# STAFF RECOMMENDATION

NCPC File No. 6383

**GEORGETOWN WATERFRONT PARK**  
WISCONSIN AVENUE TERMINUS,  
Wisconsin Avenue to 31<sup>st</sup> Street, NW,  
Washington, D.C.

January 25, 2007

**REVISED PRELIMINARY SITE PLAN FOR WISCONSIN AVENUE TERMINUS**

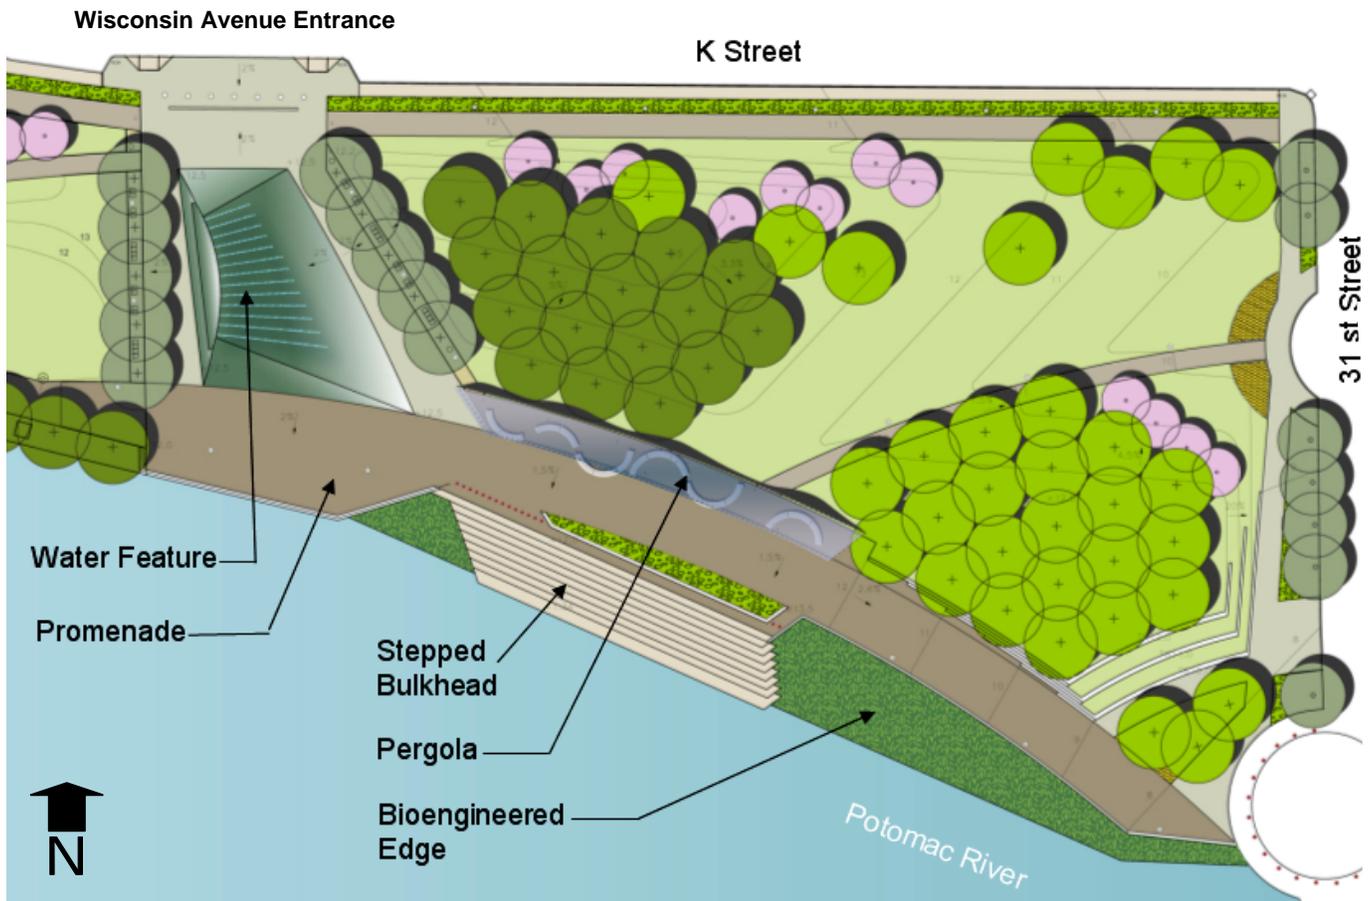
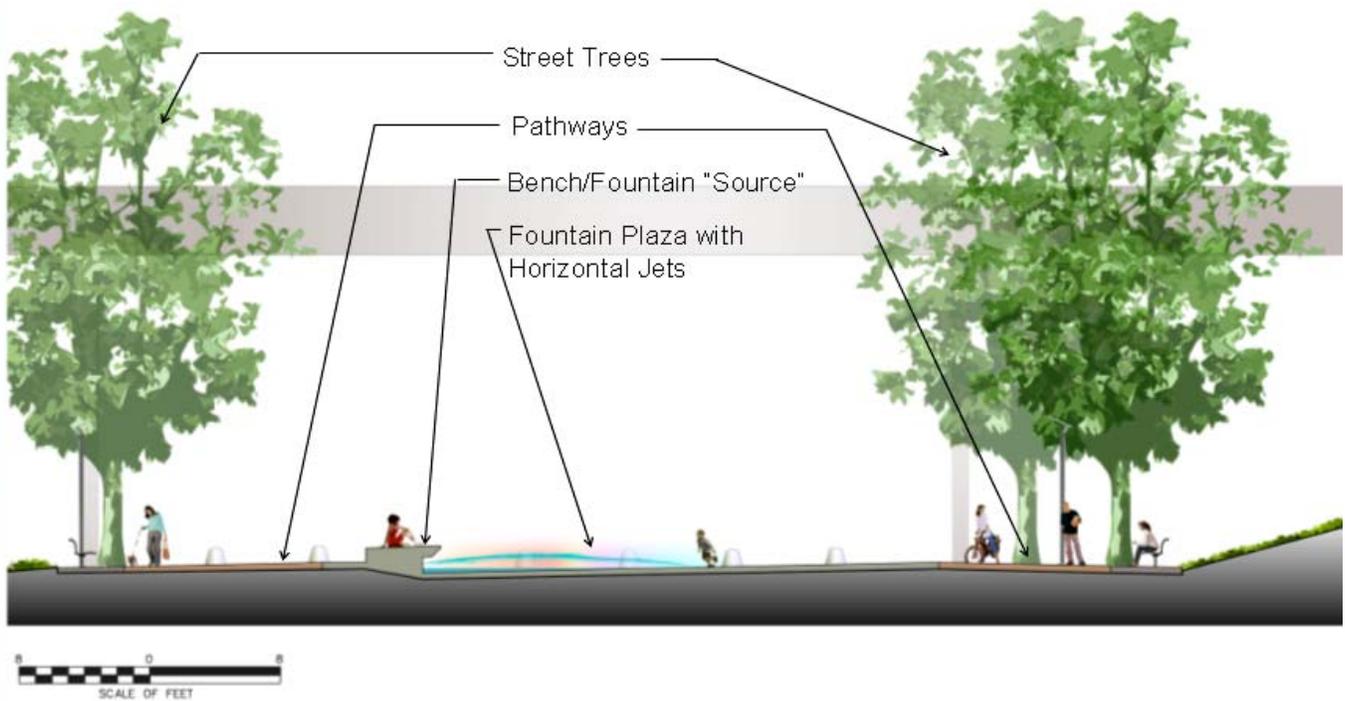
The revised preliminary plans continue to build upon the concept design provided to the Commission. The pergola at the Wisconsin Avenue central plaza area has been refined in its geometry and height. The primary materials of the pergola now involve steel structural members colored dark olive, which cant backward at an angle and have a suspended arm extending forward from the vertical forms that create the roof support of the pergola. An open metal screen

comprises the up-angle roof profile and serves to support vegetation growth the will create the shading green roof. A series of undulations along the leading edge of the pergola further augments a sense of motion to the pergola, adding a changing pattern of shade below. The seating elements are envisioned as granite, arranged in curving shapes to provide a variety of viewing orientations. The granite used for the seating will match the granite used at the fountain and overlooks, thus establishing a consistent theme for all of the park's iconic features.

The park pedestrian pavement remains as original design with areas of granite pavers as a consistent treatment of the ground plane within areas adjacent to tree-shaded seating areas. Also, the design continues the previously reviewed fountain area that has established a conventional fountain arrangement utilizing a large low-height seating area, with readily controlled low-angle jet streams. All water streams are located within an internal draining water basin.

The fountain jets are generated from a water pool located within the bench base area that is slightly submerged within the granite base and splashes onto the plaza that is defined by the use of an alternate paving pattern. The design provides a normal approach to seating around the fountain by using a large granite bench which serves the purpose of also enclosing a portion of the mechanical elements of the fountain itself. The slight depression (basin) in the paving collects the water. Pedestrians can either walk through the fountain, or around it, toward the stepped bulkhead and the shoreline promenade.

Park perimeter lighting has now been altered to feature only the single-lamp Washington Globe light standard along K Street and 31<sup>st</sup> Street.

## **REVISED PERGOLA PRELIMINARY DESIGN WITH SEATING AREAS BENEATH**

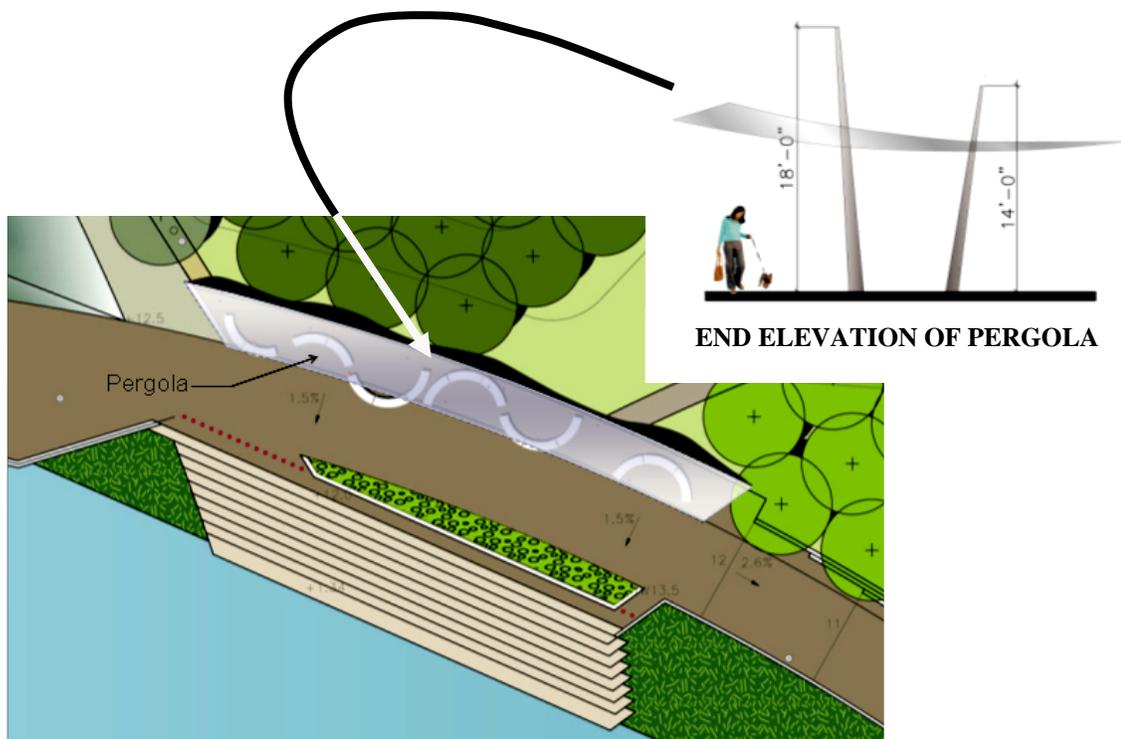
Staff **recommends approval of the revised preliminary plans** for the Wisconsin Avenue Terminus including the proposed design of the pergola structure and its attendant seating.

The revised preliminary design responds to the Commission's direction to the Park Service regarding defining the materials of the Pergola. The revisions to landscape features respond to local community meeting concerns that are now integrated into the plans regarding more informal lawn areas and fewer trees placed into those sections. The preliminary design revisions
